MEMO

SUBJECT: Response to Questions – Planned Development Amendment PDA 3-22, Large

Format Commercial Review with Waivers (LFW 1-22), Landscape Plan Review (L 6-

22), and Partition (MP 1-22)

Water

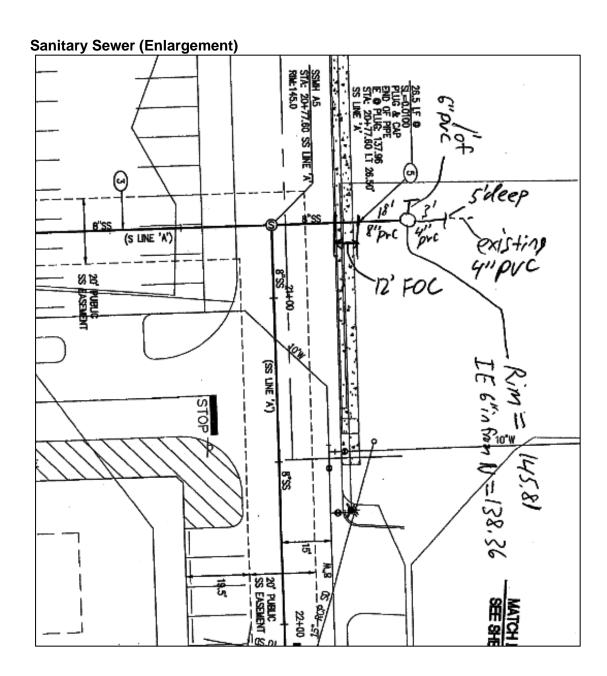
P23. The applicant's answer indicates a buildable pad of 5500 Square feet would be considered for the remaining parcel. I already read the utilities review indicated no service to that parcel at this time. Typical for an undeveloped lot? Do we even worry about that now or assume it gets covered when someone wants to develop that?

STAFF RESPONSE: The current Planned Development Amendment and partition applications are the appropriate time to ensure the new parcels have an approved utility plan to serve the properties. The applicant will be required to comply with the conditions of approval in order to file the partition plat and divide the property. Conditions include approval of the utility plan to provide utilities to the parcels.

There is a public sewer line on the property to the south and a public sewer easement extending to the southerly boundary of the subject property. While sewer isn't extended to the subject property, sewer services can be extended to the sewer main. The Engineering Department doesn't foresee sewer depth issues. As a condition of approval, the applicant is required to provide a utility plan and provide required easements.
